SERVICE BULLETIN

M-1024

SAFETY RECALL CODE 078 1989/1990 (FX/FL SOFTAIL MODELS) POSITIVE BATTERY CABLE

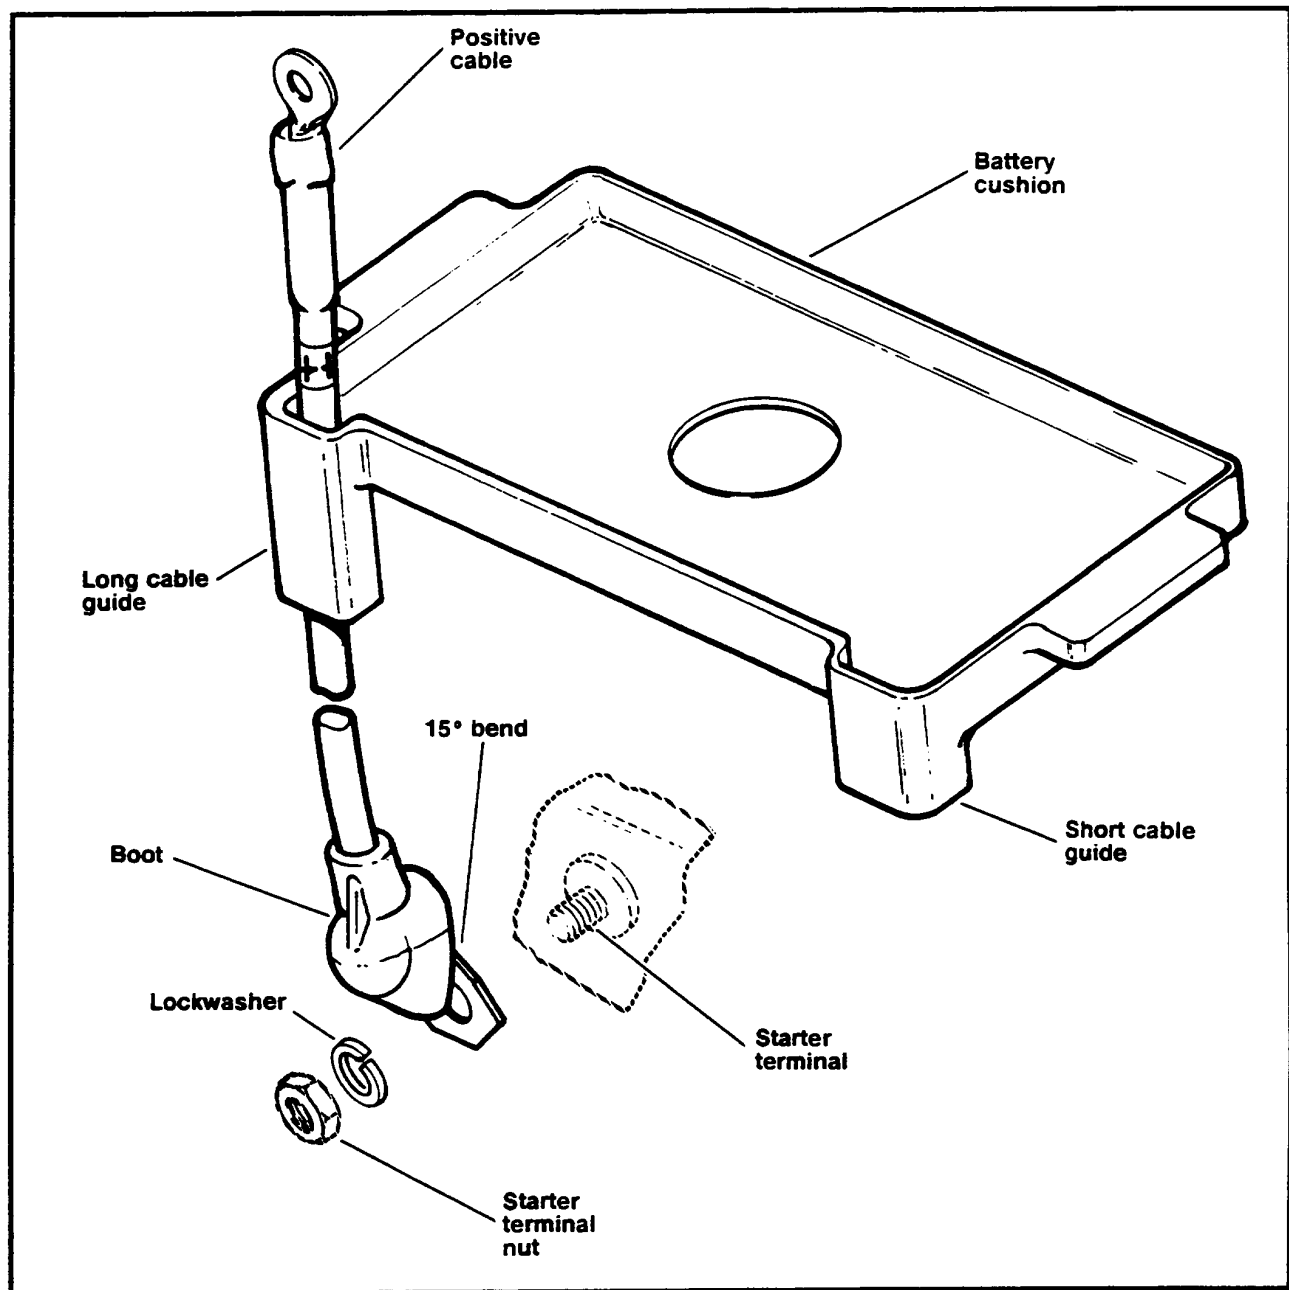
1. Remove seat.
2. Disconnect battery negative cable at battery terminal.
3. Disconnect positive cable and vent hose at battery. Remove battery and cushion.
4. Disconnect positive cable from starter. DO NOT discard cable or starter terminal nut. Cable must be returned to factory for credit.
5. See Illustration. The cable terminals have two different-sized holes; a large hole and a small hole. The small hole terminal is fastened to the battery; the large hole terminal is fastened to the starter. The starter end of the cable has a 15° bend.

The purpose of the 15° bend is to help prevent the cable being pulled tightly against the oil tank when the starter terminal nut is tightened.

Be sure the 15° bend is installed over the starter terminal so the cable leans slightly, toward the starter. This will help prevent the cable being pulled against the oil tank and chafing during vehicle operation.

9. Place the positive cable starter end over the starter terminal. Install the lockwasher and the nut. Hold cable end securely, so it does not twist and tighten nut to 65 - 80 in-lbs torque. Slide the boot over the nut and terminal.
10. Install battery. Connect vent hose. Be sure battery seats fully in the cushion and no lip of the molded cushion has been folded under the edge of the battery. Apply Armor-all® or soapy water to the cushion to ease installation.
11. Connect the positive cable first, then the negative cable. Be sure cables are not touching sides of oil tank. Check cables for kinks or tightness.
12. Install seat.
